### Town of Erie, Colorado Development Referral

**Project:** Wise Farms

**Description:** Rezoning, Planned Unit Development Overlay & Preliminary Plat

**Subject: Wise Farms, Rezoning, Planned Unit Development Overlay & Preliminary Plat**

EXHIBIT A SALE AREA  
 +27,937,355.2 S.F.  
 +642.73 AC. ± S.F.  
 2-15-2008

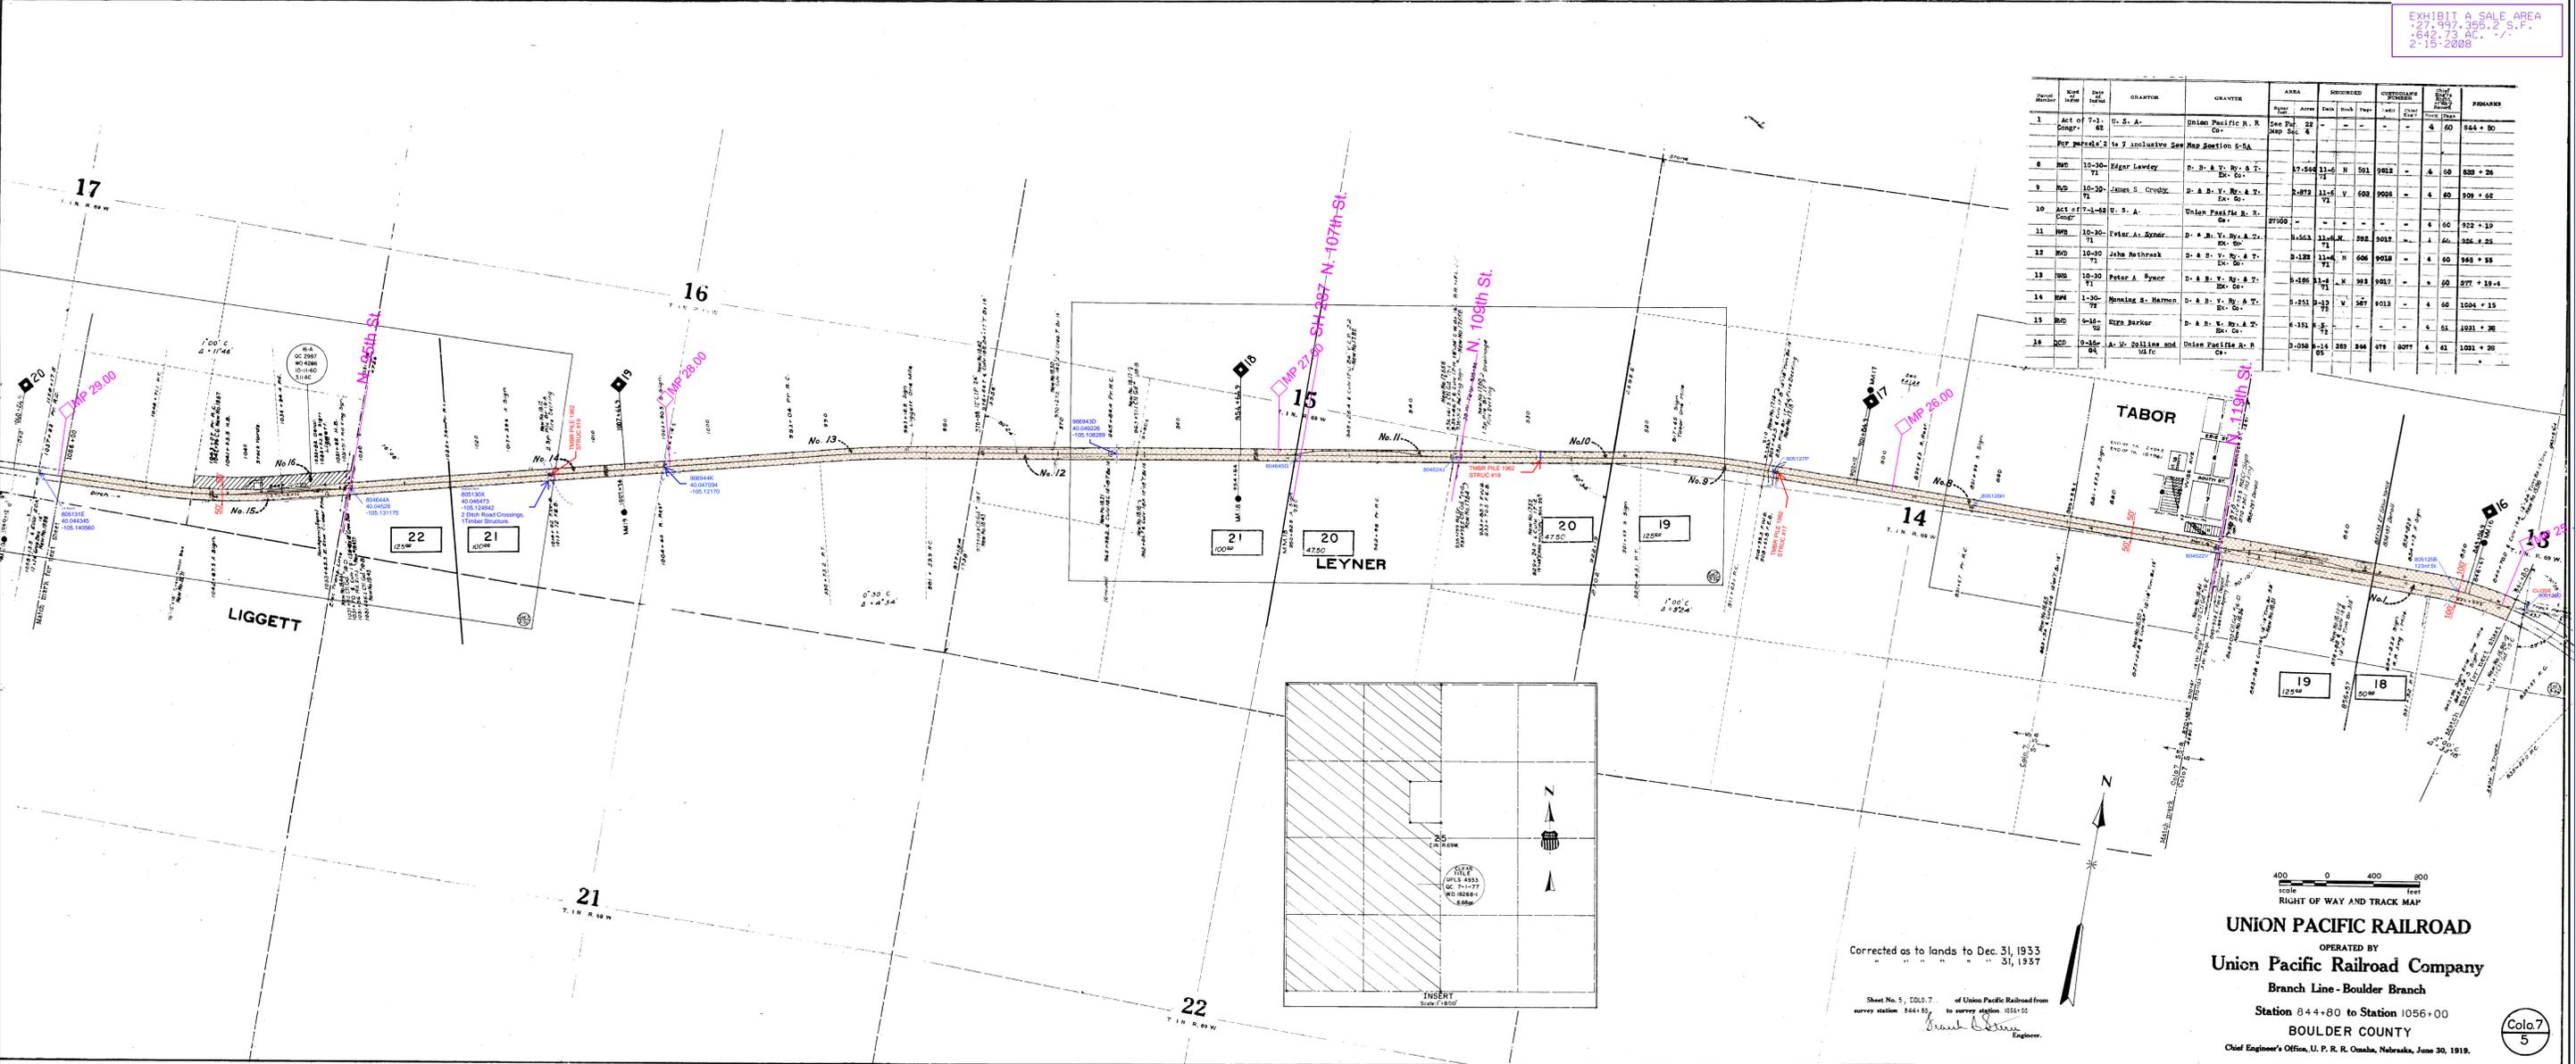
1. Please see attached exhibit for what we believe is RTD's Right-of-way (ROW) through this area, which we call Boulder Industrial Lead (BIL). The Boulder County Assessor's Office web site indicates that the RTD BIL ROW is not continuous through the development area. A land locked parcel of the BIL ROW is recorded as owned by the City of Erie. The Land Title Survey Sheets 22,23, and 24 of the Preliminary Development refer to the subject parcel as Area of Concern #4. Please provide documentation as to why you believe this area is owned by the City of Erie.
2. RTD does not grant easements. Please contact Susan Altes, RTD's Senior Manager of Real Property [Susan.Altres@RTD-Denver.com](mailto:Susan.Altres@RTD-Denver.com) 303-299-2440.
